# Modification Recommended Service Note

## E36155A 800W Autoranging Benchtop Power Supply, 60V, 40A

Serial Numbers: MY62101001 - MY63001001

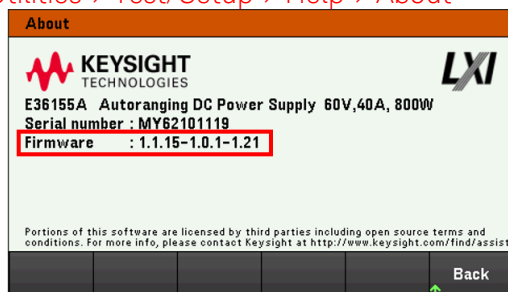
Instrument with the firmware version **1.1.10\_1.0.1\_1.16 and older**, may encounter failure during operation.

The below errors will be shown:

- Dashes "---"
- Error 614: Invalid serial number
- Error 561: Analog board (CH1) does not respond

Firmware update to **1.1.15-1.0.1-1.21** and newer is mandatory.

This firmware version resolve the booting issue when used in application with high capacitive loading.
